Revision 8 November 2021

Dealer Service Instructions for:

Customer Satisfaction Notification V41 Steering Damper

NOTE: NEW information in Figure 6, 7, 8, 13 and parts section (Fasteners).
NOTE: Fasteners MUST be replaced.

Figure 8 – Tie Rod Bracket

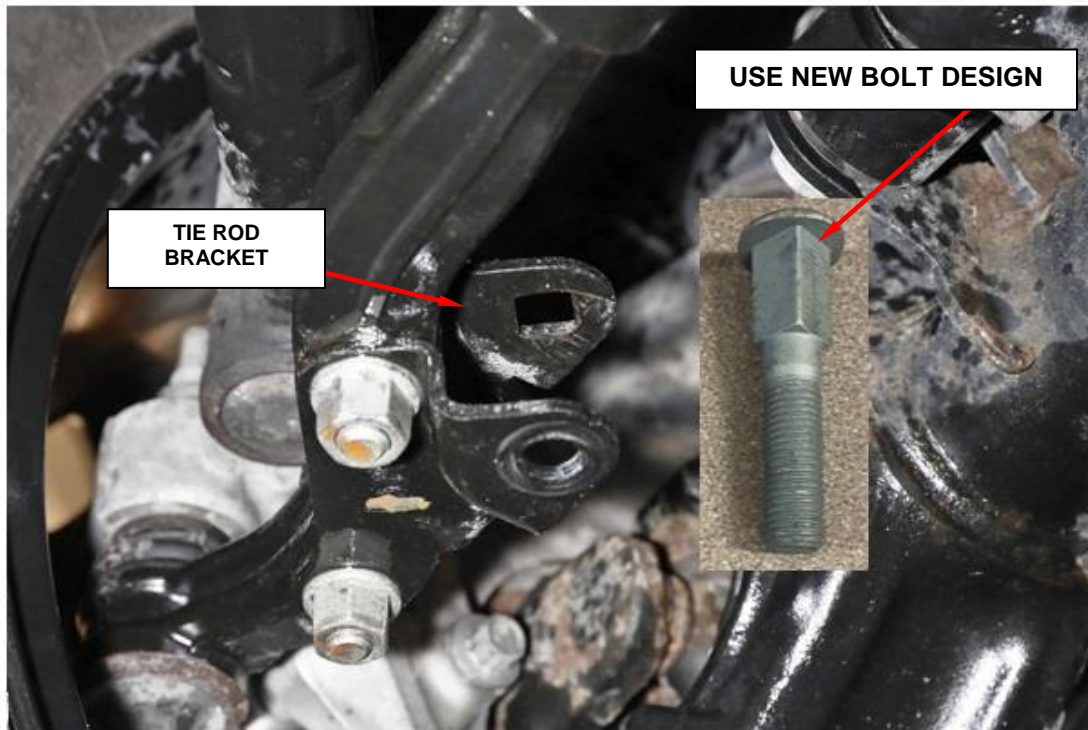
NOTE: The NEW Steering Damper Bolt has a longer square guide that must align with the tie rod bracket square hole and be fully seated (Figure 7).

13. Install the **NEW** design bolt and the **NEW** steering damper nut on the tie rod bracket and tighten to 70 N·m (52 ft. lbs.) (Figure 8).
14. After the steering damper is installed in the correct orientation (base cup bulge at 6 o'clock location) lower the vehicle on the ground (Figure 5).
15. Return the vehicle to the customer.
